Wisconsin Department of Transportation

Proposal #18:

1005-10-71
Illinois State Line – Madison
Rock River Bridges B-53-0357/0358
IH 39
Rock County

This is Addendum No. 01, which provides for the following:

PROJECT NO: 1005-10-71,72	HWY: IH-39/90	COUNTY: ROCK	TYPICAL SECTIONS	SHEET 12	E

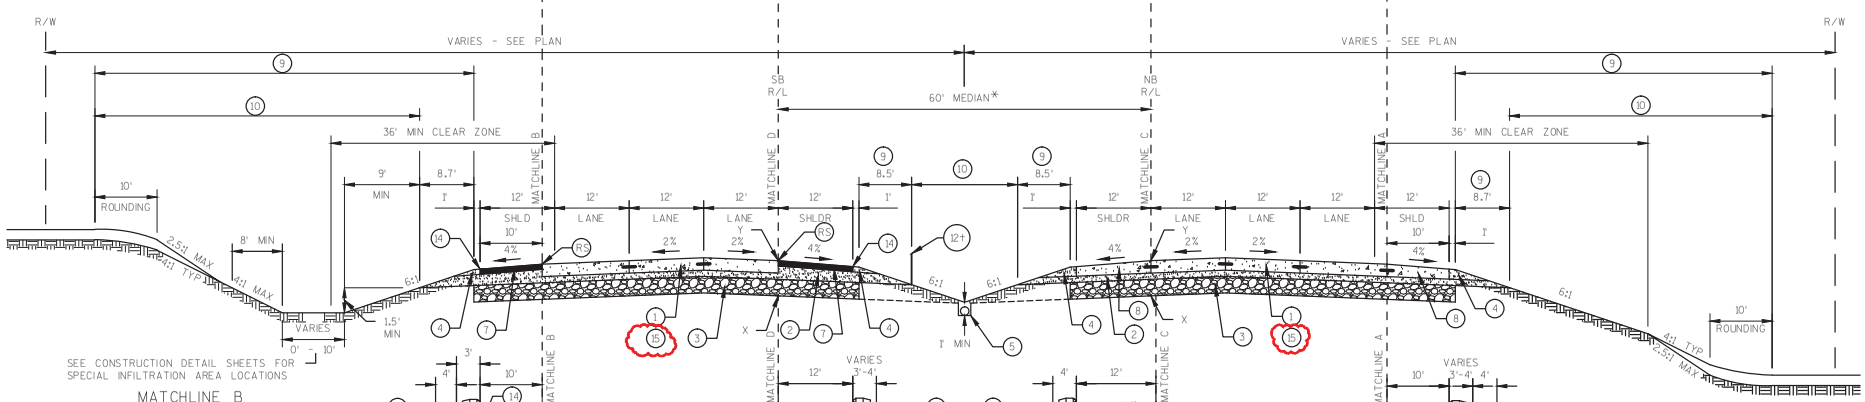
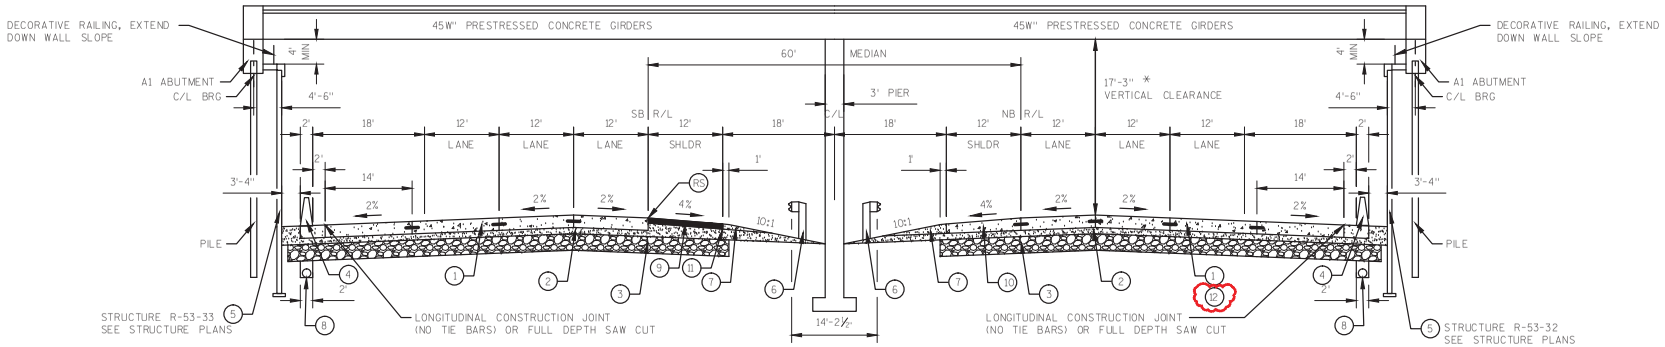
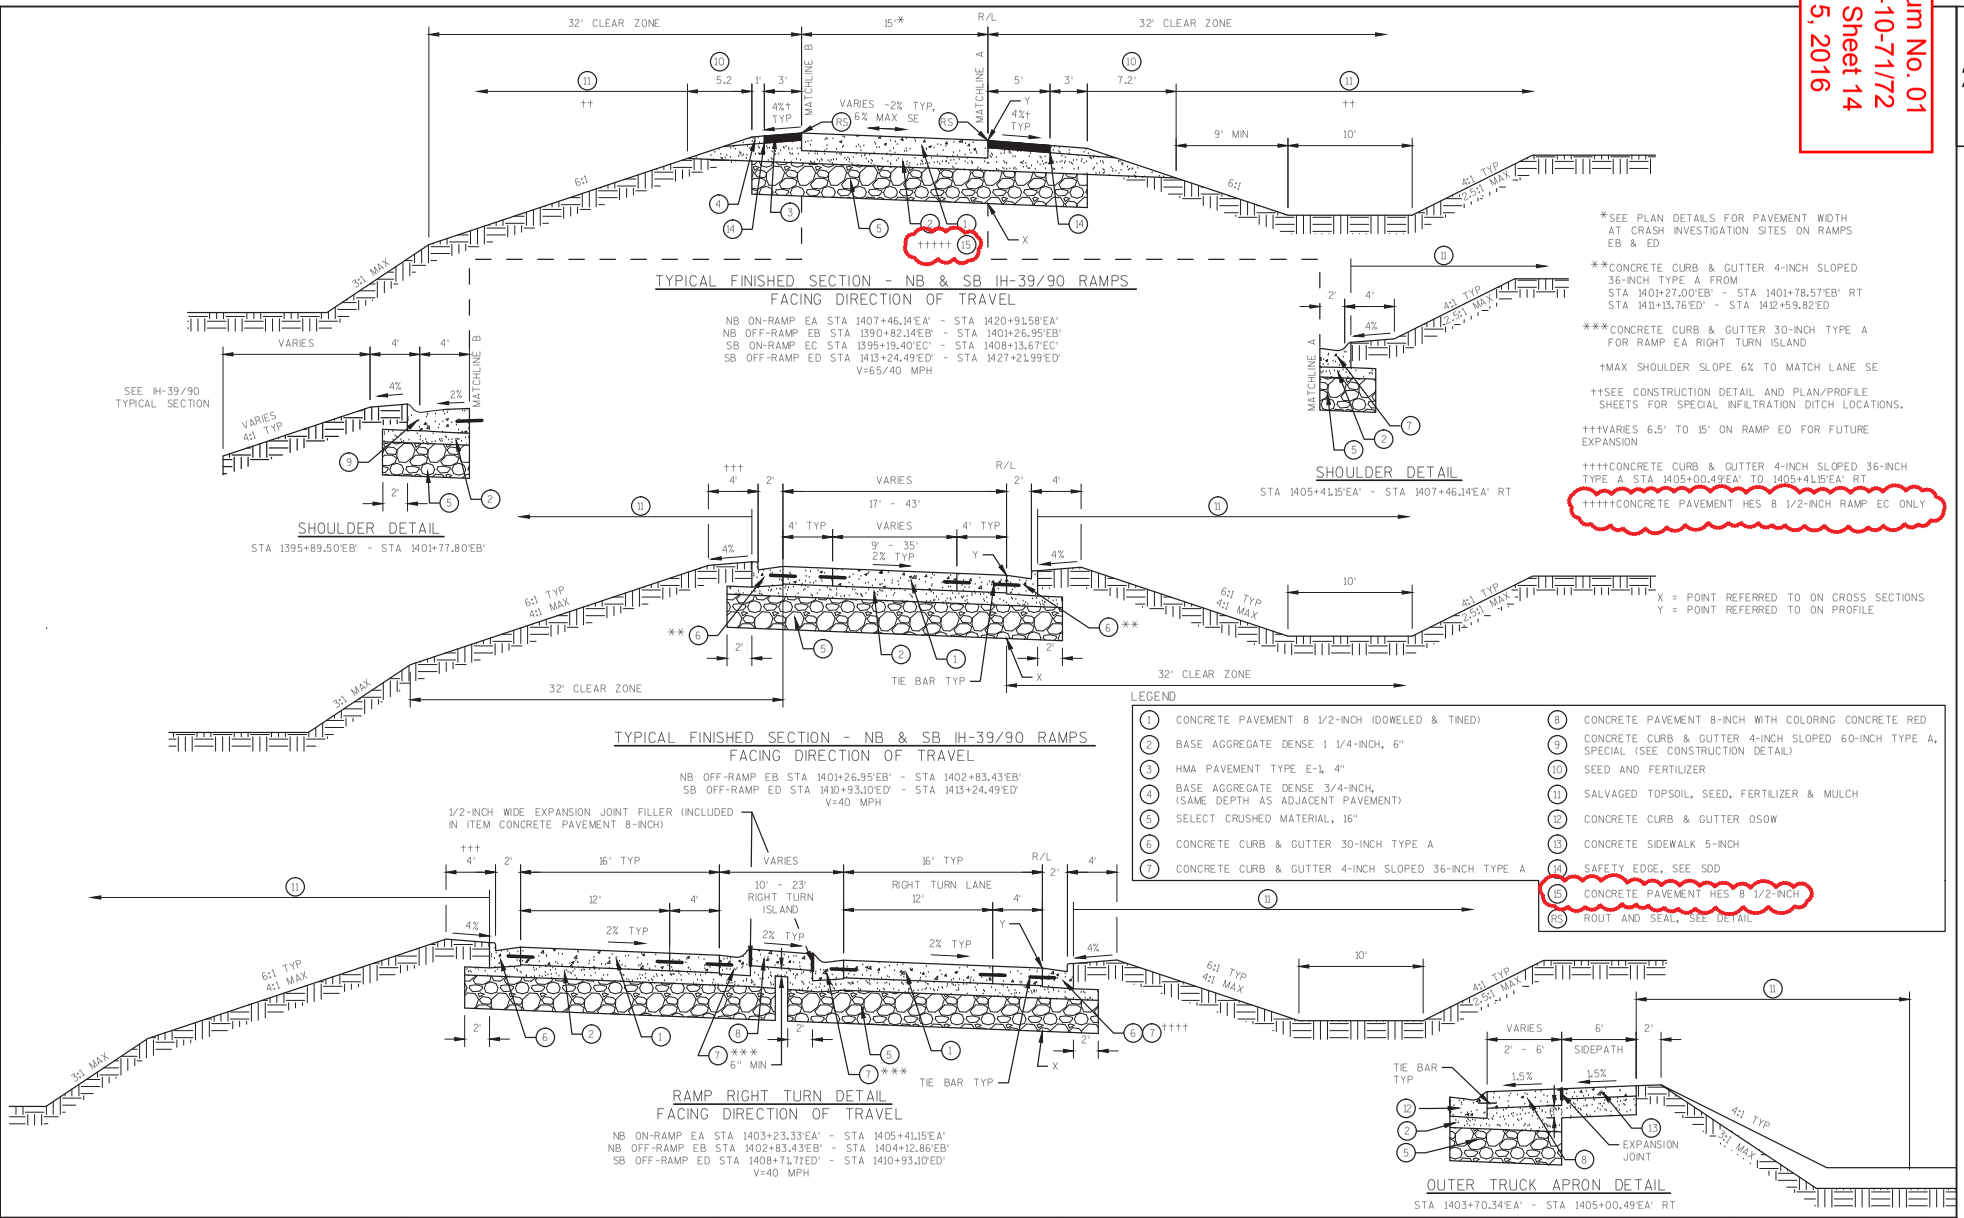
Revised Plan Sheets	
Plan Sheet	Plan Sheet Title (brief description of changes to sheet)
12-14	Finished Typical Sections (added call-off for Concrete Pavement HES)
33	Construction Details (added Private Entrance to Rural and Urban Driveway Table)
154-155	Plan Details (clarified limits of Concrete Pavement HES)
159-165	Plan Details (clarified limits of Concrete Pavement HES)
171	Plan Details (clarified limits of Concrete Pavement HES)
747	Miscellaneous Quantities (added quantity for Asphaltic Surface Driveways and Field Entrances)
754	Miscellaneous Quantities (revised quantity for Apron Endwalls for Culvert Pipe Sloped Side Drains Steel 30-inch 4 to 1 and 6 to 1 and Pipe Grates)
1149	Structure B-53-357 (revised pre-bore note under “Foundation Data”)
1163	Structure B-53-357 (revised pre-bore depth under “Notes”)
1164	Structure B-53-357 (revised pre-bore depth under “Notes” and moved “Bill of Bars” info to new sheet 1,164A)

Addendum No. 01
ID 1005-10-71
Revised Sheet 1196
January 5, 2016

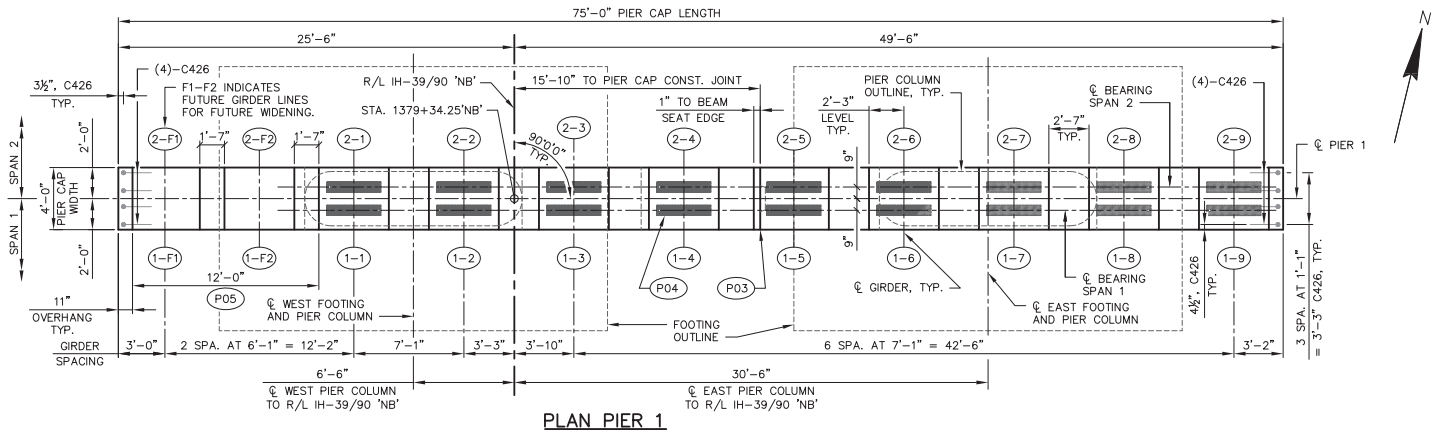
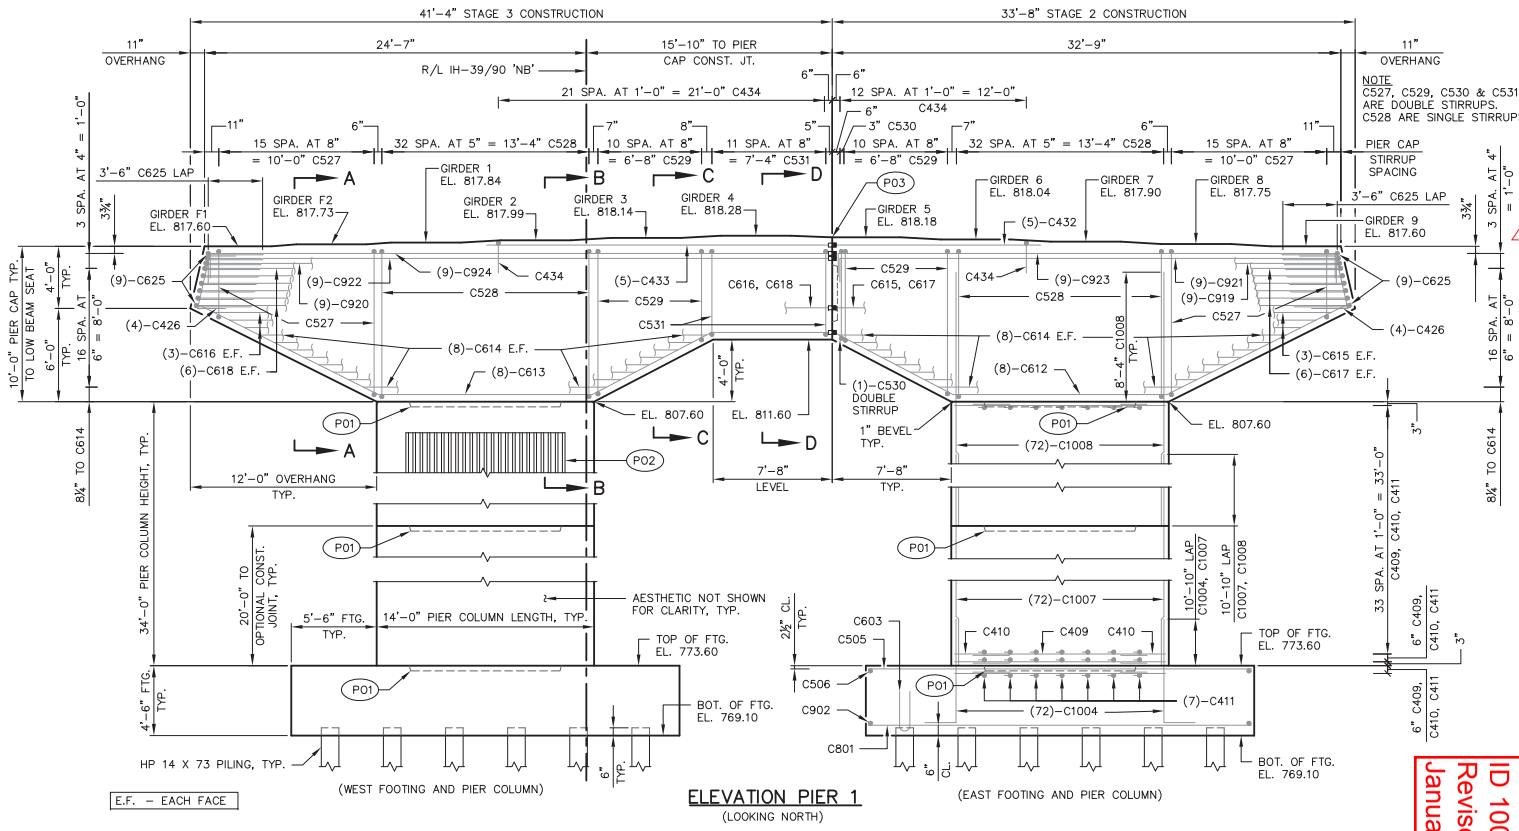
1196	Structure B-53-358 (revised pre-bore note under “Foundation Data”)
1211	Structure B-53-358 (revised pre-bore depth under “Notes”)
1212	Structure B-53-358 (revised pre-bore depth under “Notes” and moved “Bill of Bars” info to new sheet 1,212A)
1276	Structure R-53-32 (revised dimension on “Section Thru Wall At Gates” detail)
1281	Structure R-53-33 (revised dimension on “Section Thru Wall At Gates” detail)
1469	Cross section STA 1386+00 (revised pipe size/class label)
1578	Cross section STA 1386+00 (revised pipe size/class label)
